Item 5.**Development Application: 18 City Road, Chippendale - D/2020/873**

File No.: D/2020/873

Figure 12: Section - PDA/2019/237

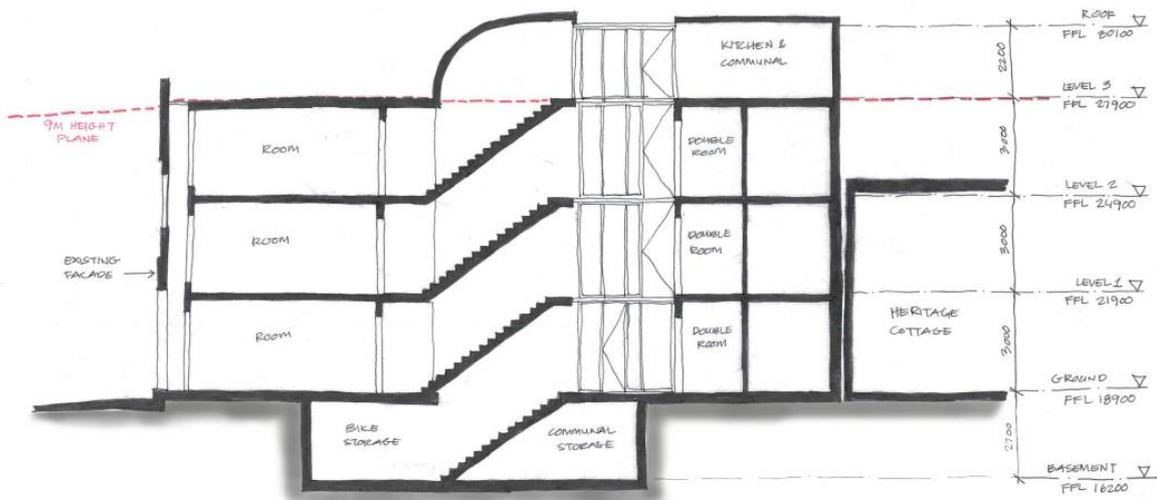
- **PDA/2019/237** – Pre-development application advice was issued for the proposal for the adaptive reuse of the existing building for student accommodation over three levels, ground floor retail tenancy and rooftop communal open space (see section figure 12). The applicant was advised that the extent of demolition leaving two street wall facades for aesthetics was not supported, along with the height variation and the amenity of rooms with light and ventilation access only from a void.

- PDA/2019/335** – Pre-development application advice was sought for a 14 bedroom, 20 person boarding housing, behind the retained facades to City Road and Elim Place (see figure 13 and 14 showing elevations of the proposal). The applicant was advised that changes to the facade including additional windows, enlargement of windows and the additional storey which intersects the parapet were not supported. In addition, it was advised that the floor levels of the existing building should be retained and the steel staircase, communal space at basement level, ground floor bedrooms fronting City Road, FSR and height variations were not supported.

Figure 27: Streetscape analysis

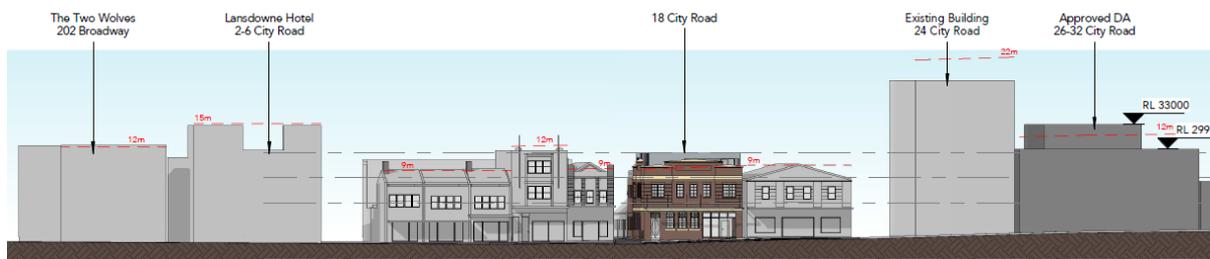
- 58. The surrounding area has a varied character and built form, with a mix of commercial, residential and tourist and visitor accommodation buildings ranging from 1-6 storeys. A six storey heritage item is located at 22-24 City Road to the south, a 5 storey boarding house development (currently under construction) is located at 26-30 City Road to the south and a three storey building is located at 12 City Road to the north. Buildings on City Road generally increase in height on the approach to Broadway shopping centre.

Figure 28: 3m setback requirement shown in green

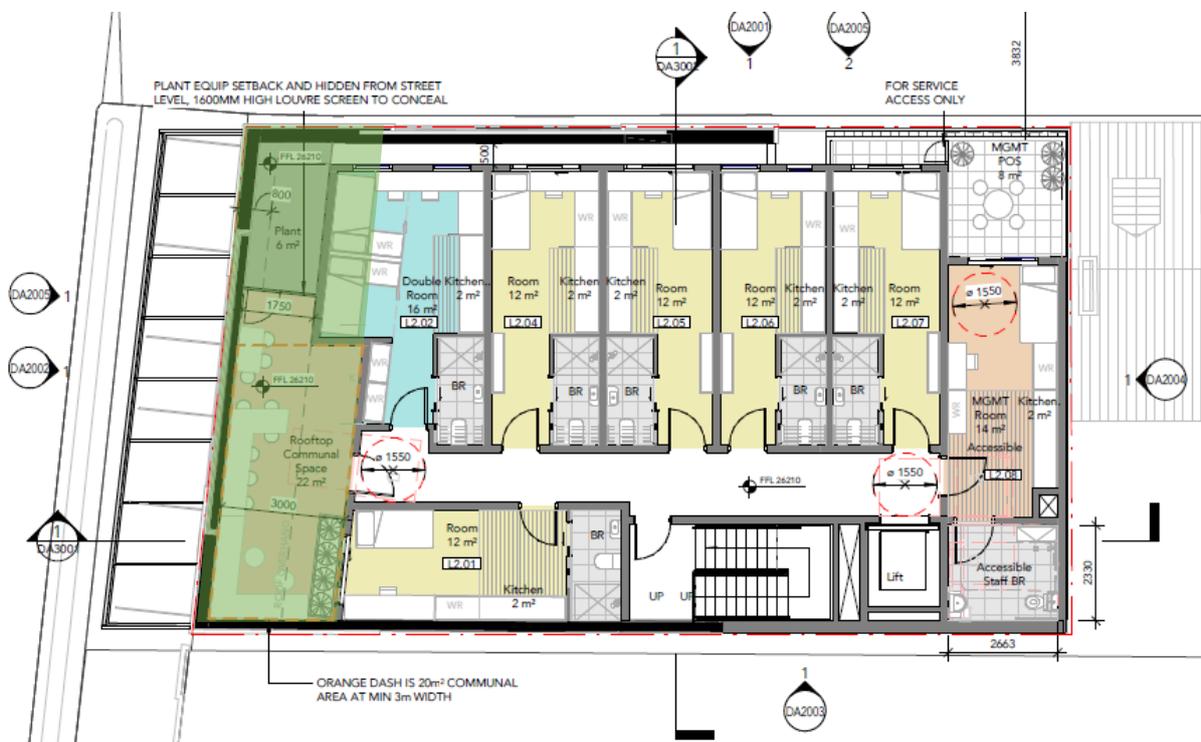
60. Council's Heritage and Urban Design Specialists have recommended that the third storey is setback 3m from the parapet of the contributory building fronting City Road to reduce the impact on the contributory building in accordance with section 3.9.7 of the DCP. The 3m setback will decrease views of the third storey from the public domain and respect the built form of the contributory building. This area should be free of all building structures, including the roof overhang and rooftop plant. The setback should form a consistent line for the entire length of the third storey and should not include any steps in form.

61. This additional setback will require the reduction of boarding rooms on the second floor. However, it will result in additional (improved quality) communal open space which is a positive amenity outcome for future occupants of the site.

62. Subject to the inclusion of this condition, the height, bulk and scale of the proposed development is compatible with the surrounding locality. An appropriate deferred commencement condition is recommended.
